Answers to Diamond Pixel Modules Proposal for the ATLAS Inner Detector Upgrade Referee Questions/Comments

Harris Kagan, Marko Mikuž, William Trischuk
December 2007

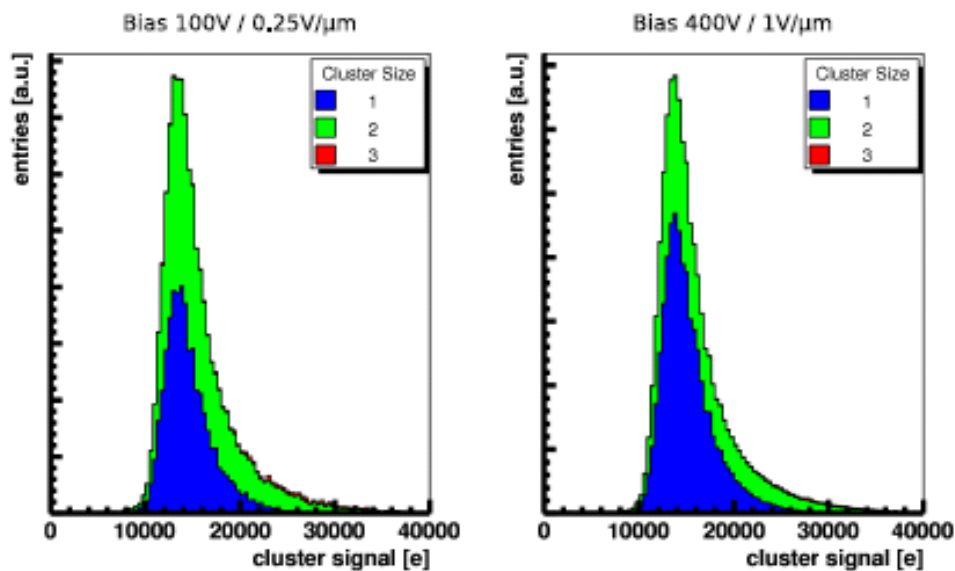
- Plot the exponent of the exponential decay of the charge collected vs. fluence as a function of the initial charge collection distance.

- Extract the expected charge collected as a function of fluence for the new sensors with CCD ≥ 300

The proposal has been updated to include a proper damage curve ($1/ccd = 1/ccd_0 + k\Phi$). The damage constant is roughly $k \sim 10^{-18} \text{ cm}^2/\text{micron}$.

Recent diamonds measured by RD42 have shown damage consistent with a k of $k \sim 10^{-18}$. This now includes small scCVD samples that have initial collection distances in excess of 400 microns. We don't expect the higher quality pCVD material to be any different. The formula which describes the data is $1/ccd = 1/ccd_0 + k\Phi$, with k independent of the initial collection distance

ccd₀.

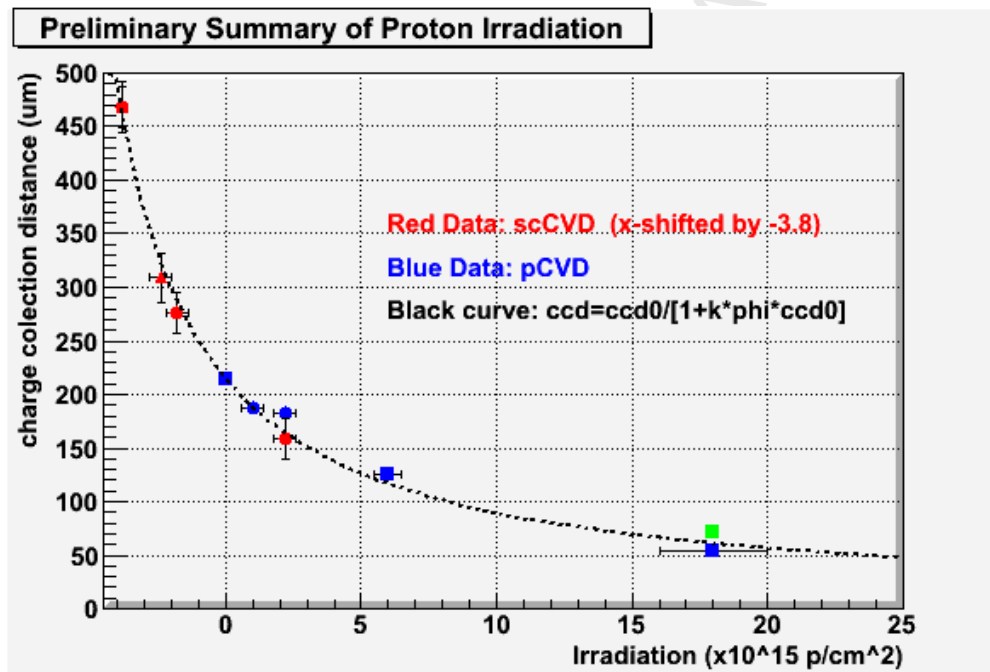
2. Resolution: Si achieves 10 micron, better than 50 micron/ $\sqrt{12}$ ~ 14 micron. Add that diamond resolution is measured, needs to be better measured, and show the results.

The proposal now includes a plot with 19.4 microns resolution and states that the telescope resolution was 11 microns leading to 16 micron position resolution in the diamond module. We are looking for a plot of the 'final' results on the pCVD module that indicated a sensor resolution of 14 microns. We expect that this will improve with the irradiation. The first test of the irradiated module was in October 2007. Results are expected over the winter.
